# UNITED STATES PATENT AND TRADEMARK OFFICE

APPLICATION NO.	FILING DATE	FIRST NAMED INVENTOR	ATTORNEY DOCKET NO.	CONFIRMATION NO.
10/581,584	06/11/2007	Ulrich Bantle	VO-768	7001
43419 7590 07/17/2008 PAULEY PETERSEN & ERICKSON 2800 WEST HIGGINS ROAD SUITE 365 HOFFMAN ESTATES, IL 60195				
EXAMINER				
SULLIVAN, MATTHEW J				
ART UNIT		PAPER NUMBER		
3677				
MAIL DATE		DELIVERY MODE		
07/17/2008		PAPER

### Office Action Summary

## DETAILED ACTION

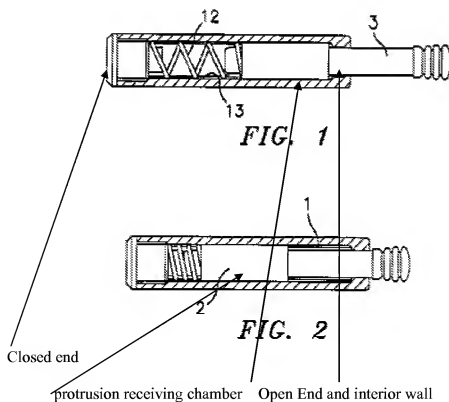
Regarding **Claim 14** and **36**, Salice '617 clearly teaches a door-closing damper where at least one protrusion (see below) is formed on the interior wall section (8) of the receiving chamber (see below) associated with the open end of the damper body which contacts at least one sliding face (see below) of the sliding element (3).

Regarding **Claim 15**, Salice '617 further teaches a door-closing damper with at least one protrusion (2) is formed on the sliding element (2-5, collectively) which during the at least partial pull-out of the sliding element out of the receiving chamber strikes the protrusion (see below) formed on the interior wall section of the receiving chamber associated with the open end of the damper body (1).

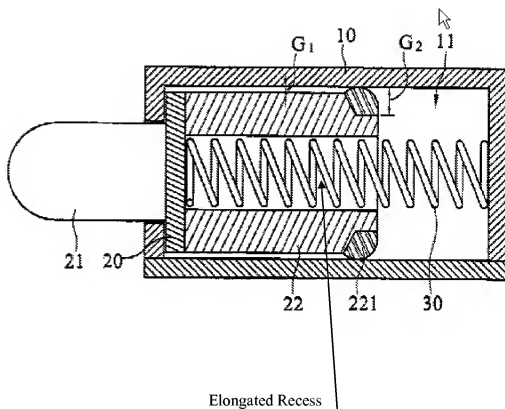
Regarding **Claim 39**, Salice '617 clearly teaches a stop element (6) with a detent head (see below) which projects at least partially over an edge area (see fig. 2) of an opening (7) at the open end of the damper body which with the sliding element pushed-in is stopped on the edge area.
